Access Compliance Report

Public Rights-of-Way

(Curb Ramps)

Intersection ID: 30556	Main Street: GREEN_LEA_CT	Cross Street: GREENCREEK_DR	Location: W
ADA ID: 5EB54A79B69C	Ramp Type: PerpDiag	Initial Pass/Fail: Fail	Overall Compliance: No
Severity Score: 12.5			
Codes/Mitigation Info/Possible Solution		Field Measurements/Component Compliance

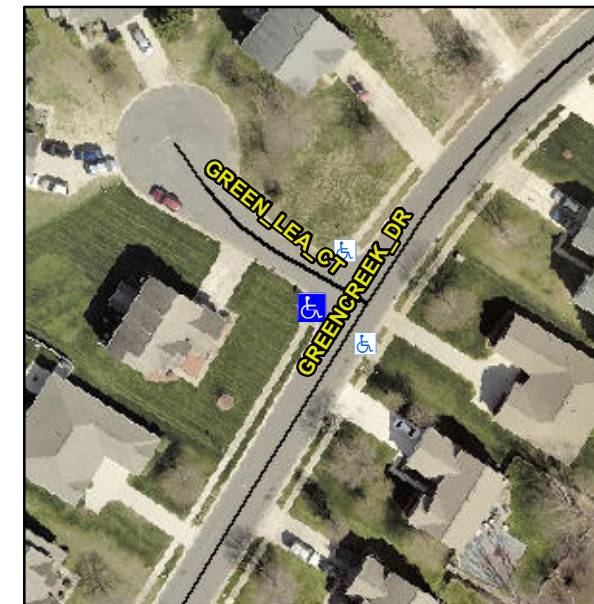
Compliance	Description	Data	Compliance	Description	Data
N/A	Ramp Length (in)	48.0	No	Ramp Slope (%)	8.9
Yes	Ramp Width (in)	48.0	Yes	Ramp XSlope (%)	1.5
N/A	Flare Type LT	N/A	N/A	Flare Type RT	N/A
N/A	Flare Slope LT (%)	N/A	N/A	Flare Slope RT (%)	N/A
N/A	Flare Traversable LT?	N/A	N/A	Flare Traversable RT?	N/A
N/A	Landing Length (in)	N/A	N/A	DWS Provided?	N/A
N/A	Landing Width (in)	N/A	N/A	DWS Contrast?	N/A
N/A	Landing Slope (%)	N/A	N/A	DWS Length (in)	N/A
N/A	Landing X Slope (%)	N/A	N/A	DWS Full Width?	N/A
N/A	Landing Curb? (Y/N)	N/A	N/A	DWS Offset (in)	N/A
N/A	Shared Landing?	N/A			
N/A	Gutter Ponding?	N/A	N/A	Gutter Slope (%)	N/A
N/A	Gutter Lip Ht (in)	N/A	N/A	Gutter X Slope (%)	N/A
N/A	Painted X Walk1?	No	N/A	Painted X Walk2?	No
	X Walk 1 Direction	To SE		X Walk 2 Direction	To NE
N/A	X Walk 1 Width (in)	N/A	N/A	X Walk 2 Width (in)	N/A
	X Walk 1 Slope (%)	2.6		X Walk 2 Slope (%)	1.2
	X Walk 1 X Slope (%)	2.4		X Walk 2 X Slope (%)	1.9

N/A	Ramp inside XWalk1?	N/A	N/A	Ramp inside XWalk2?	N/A
	Road Slope (%)	1.4	N/A	Clear Space?	N/A
	Road X Slope (%)	6.1	N/A	Clear Space to XWalk (in)	N/A
N/A	Any Obstructions?	N/A	N/A	Storm Grate/Utility Hazard?	N/A
	Obstruction Type			Storm Grate/Utility Type	
		N/A			N/A
			Yes	Surface Condition? (G/P)	Good

Remove & Replace Curb Ramp With Two New Directional Ramps or Equivalent.
